MEMO TO: Distribution

FROM: Jim Strait

SUBJECT: Yoke, Skin, and Magnet End Dimensions

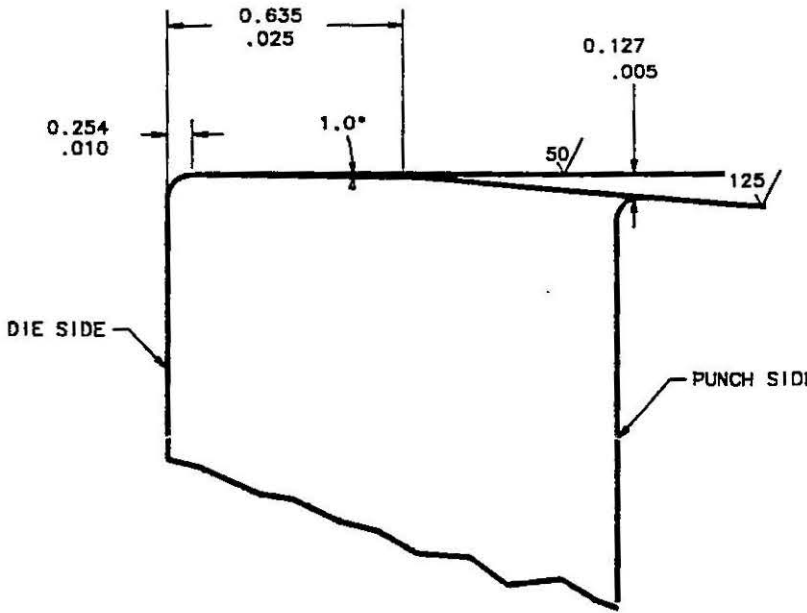
- [1] The hole near the outer radius for yoke pack stacking pins and the notches for the fiducial bar have been moved radially inwards by approximately 0.25 mm (0.010") to accommodate the slightly smaller yoke O.D.
- [2] The end yoke is 19 mm in radial thickness and extends from the end of the body yoke to the end plate. It is included principally as a mechanical element to support the skin and eliminate the large bending stress where the skin would otherwise "fall" off the end of the yoke. It is not decided yet whether it will be made of low carbon steel or high manganese stainless steel. David Orrell has made a preliminary estimate that if it were magnet steel, the field in the magnet end would increase by about 7%.

- [3] The cooling channels have been moved down about 9 mm (0.354") to clear the end yoke. The yoke stacking holes and yoke-yoke alignment key slots have been moved down to maintain the same relationship to the bus slot.
- [4] The actual radius of the current design for the end clamp is 99 mm (3.9"). Additional radial space is reserved for the possibility of making the end clamp of aluminum which requires it to have a greater radial thickness.

PROPOSED MAGNET END  
 RADIAL DIMENSIONS (mm)  
 J. STRAIT 6-28-90

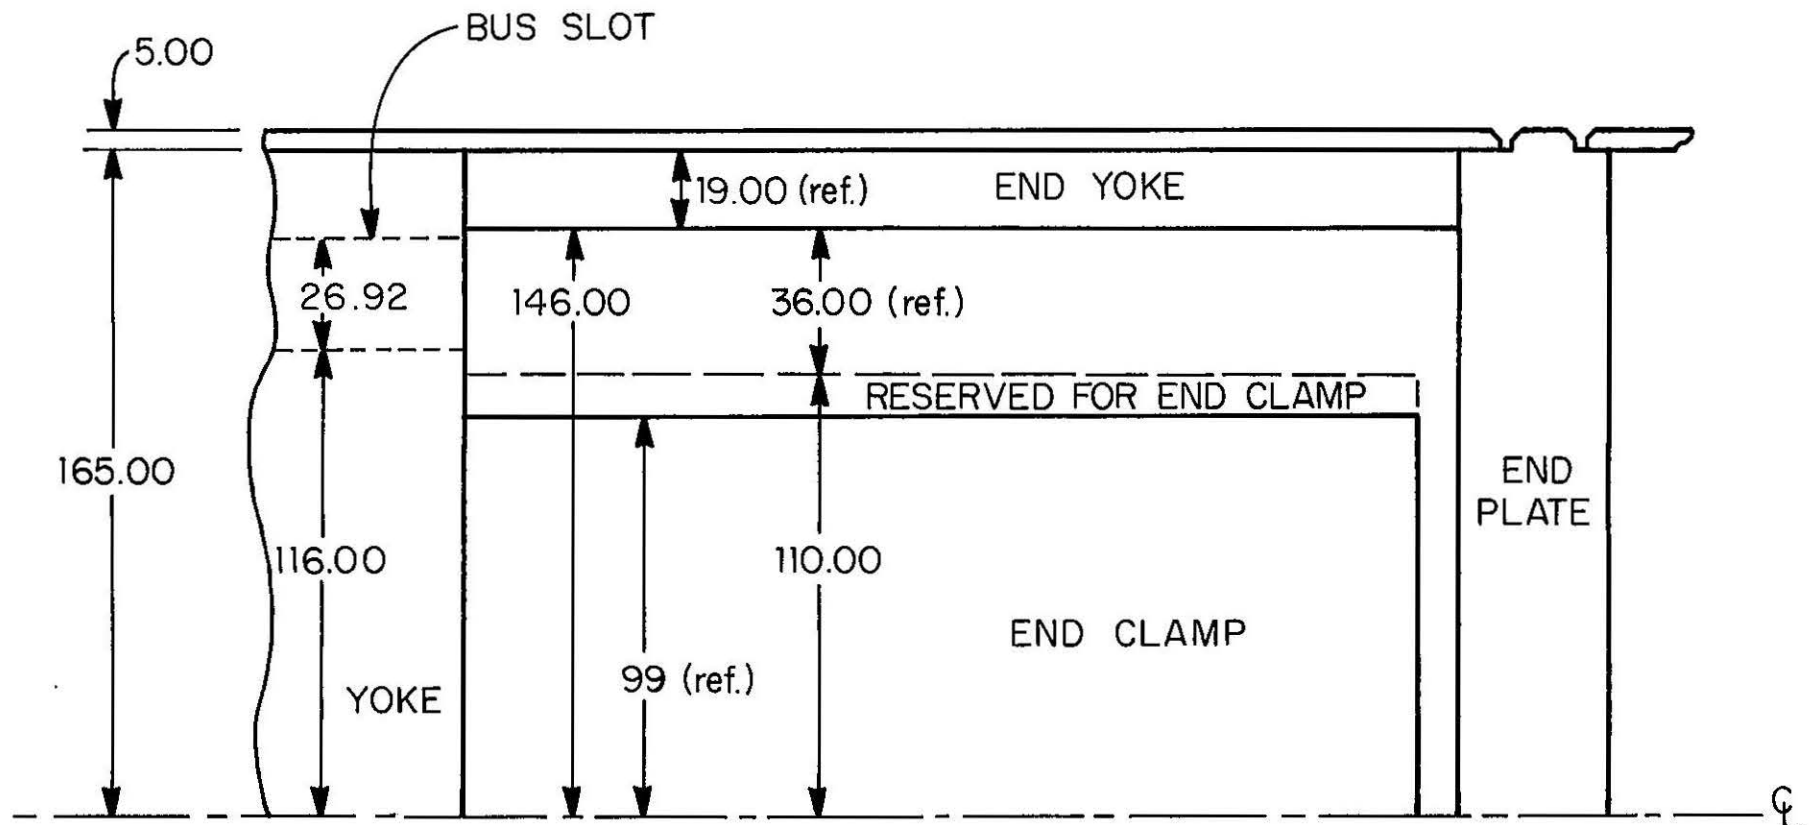
Skin thickness	5.00 mm	(0.197")
Yoke outer radius[1]	165.00 mm	(6.496")
End yoke inner radius[2]	146.00 mm	(5.748")
Radius of inner edge of bus slot[3]	116.00 mm	(4.567")
Bus slot height	26.92 mm	(1.060")
Bus slot half width	22.99 mm	(0.905")
Maximum outer radius of end clamp (minimum radius for expansion joint, ect.)[4]	110.00 mm	(4.331")
